Common Public Radio Interface

P802.1CM/D1.0 Timing accuracy ballot comment

P802.1CM/D1.0 sub-clause 6.3 comment

CPRI requirements refinements rationales (3/3)

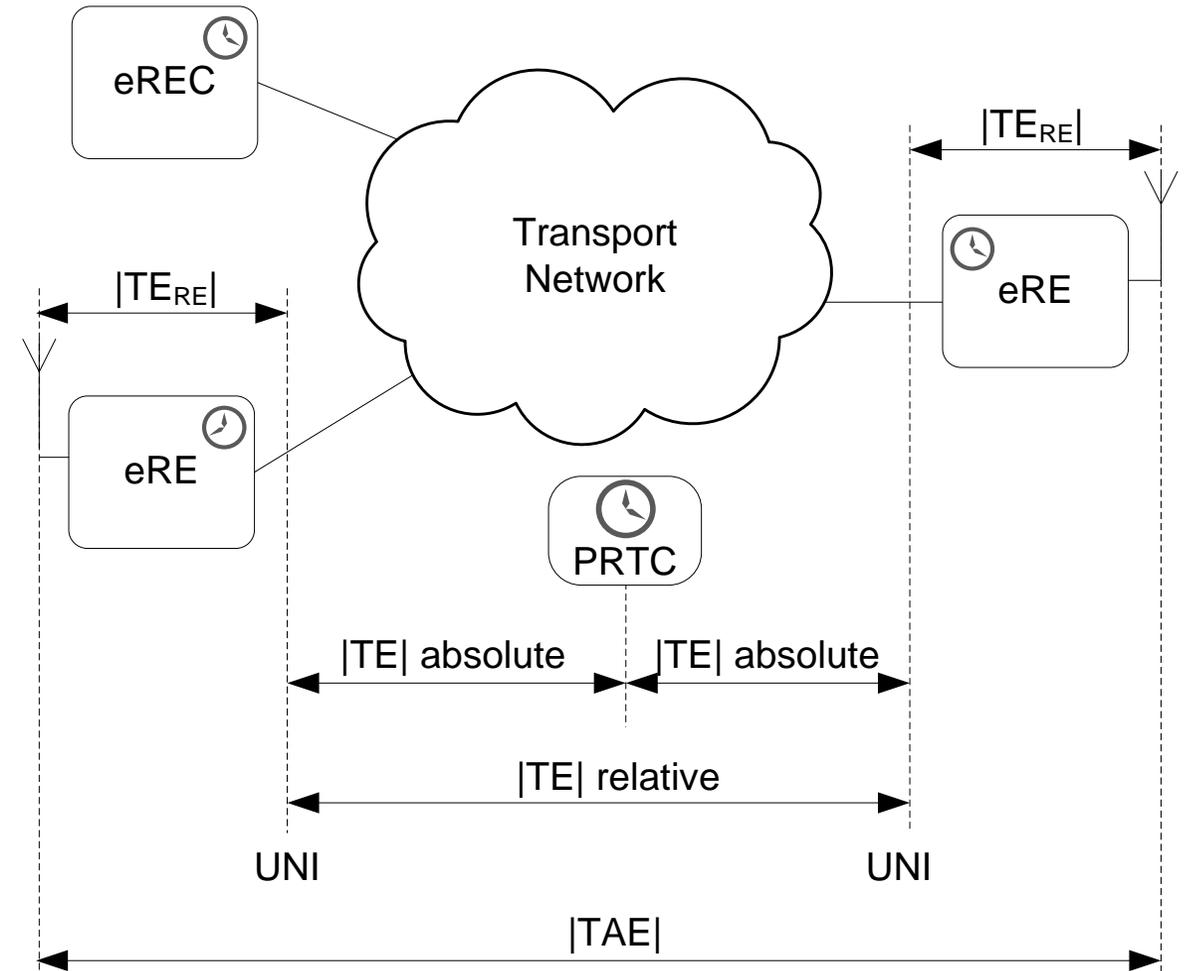
For Interface conditions for Case 1, eCPRI Transport Network Requirements considers two sub-cases:

- the integrated T-TSC requirements are the same as standalone T-TSC Class B as defined in [ITU-T G.8273.2].
- the enhanced integrated T-TSC requirements assume a total maximum absolute time error of 15ns.

As a consequence the requirements have to be revised.
